BEFORE THE IDAHO PUBLIC UTILITIES COMMISSION

IN THE MATTER OF AVISTA'S 2020
ELECTRIC INTEGRATED RESOURCE
PLAN

CASE NO. AVU-E-19-01

COMMENTS OF THE
COMMISSION STAFF

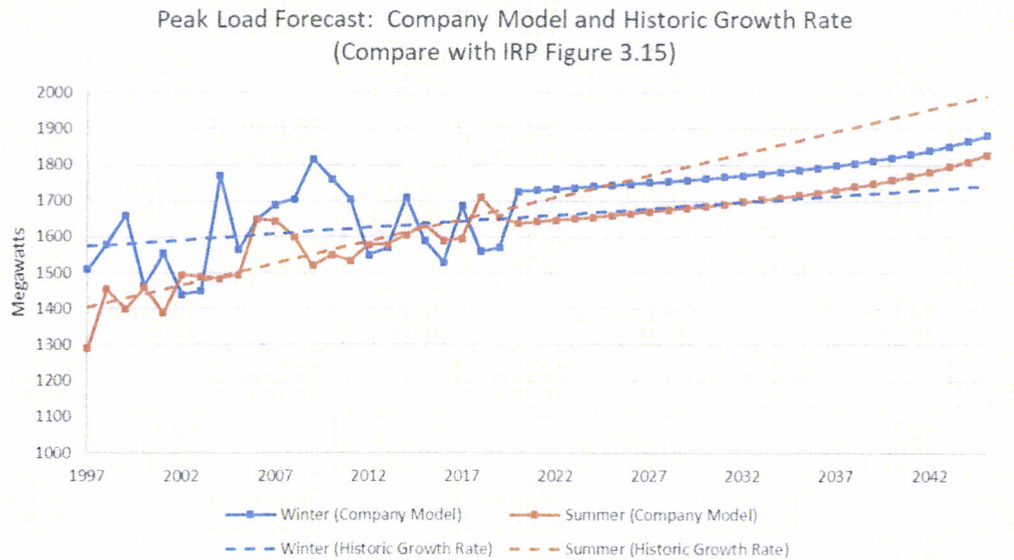
The Company's peak load forecast assumes that the Company will remain a winter peaking utility through calendar year 2045, and that winter and summer peak loads will increase at 0.3 percent per year and 0.4 percent per year, respectively. IRP at 3-18. Staff is not convinced that these assumptions are sound. Although historically a winter peaking utility, summer peaking events have become more common in recent years. In fact, the Company's system peak has occurred during the summer in six out of the past ten years. Although the Company's winter peak has grown at a modest rate of 0.2 percent per annum, its summer peak has grown at a rate of 0.8 percent per year, or twice the rate assumed in the Company's 2020 IRP. *See Figure No. 1.*

Figure No. 1: The Company's model assumes that Avista will remain a winter peaking utility throughout the IRP planning period; however, the data indicates that the utility is currently a mixed summer/winter peaking utility. Given current trends, Staff believes it likely that summer peaking events will dominate over the IRP planning period.
